URGENT FIELD SAFETY NOTICE

Name of product affected: Biplex vascular grafts and Biplex BioValsalva Conduits (stentless and stented)

FSCA identifier: CAPA 167

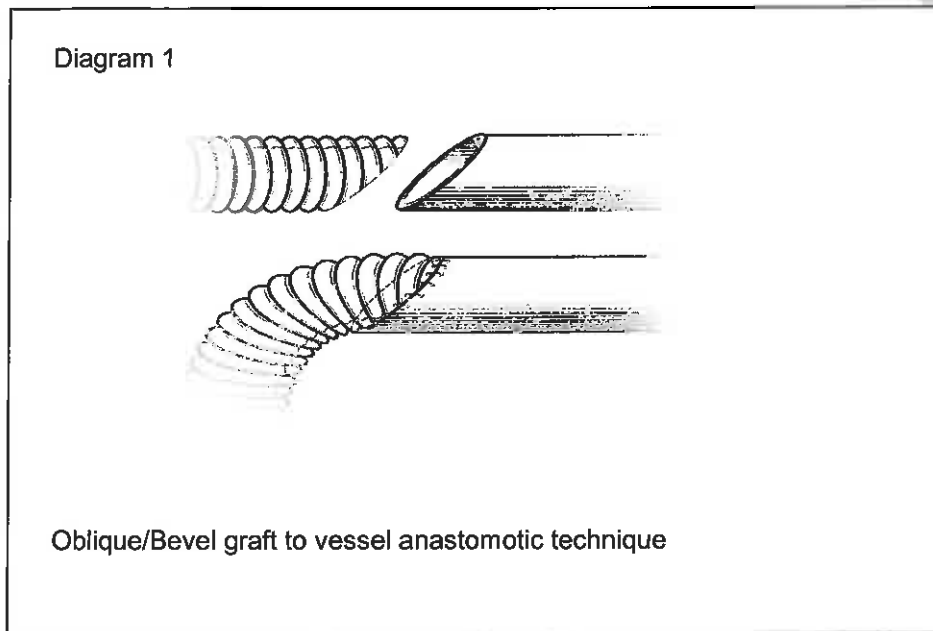
1. It is essential that the sutures are tightened each time they are passed through the material.
2. In order to achieve a smooth suture line and good haemostasis, it is important that the graft diameter selected must not be oversized relative to the distal anastomotic site.
3. Care should be taken not to apply excessive tension at the distal anastomosis by ensuring the graft is cut to the correct length.
4. The use of haemostatic agents/ accelerants and/or felt/ pledgets may reduce the incidence of suture line bleeding and resternotomy.
5. The use of an oblique/ bevel graft to vessel anastomosis is recommended. This technique will minimise any blood leakage arising from the oversizing of the graft relative to the native vessel (see Diagram 1)
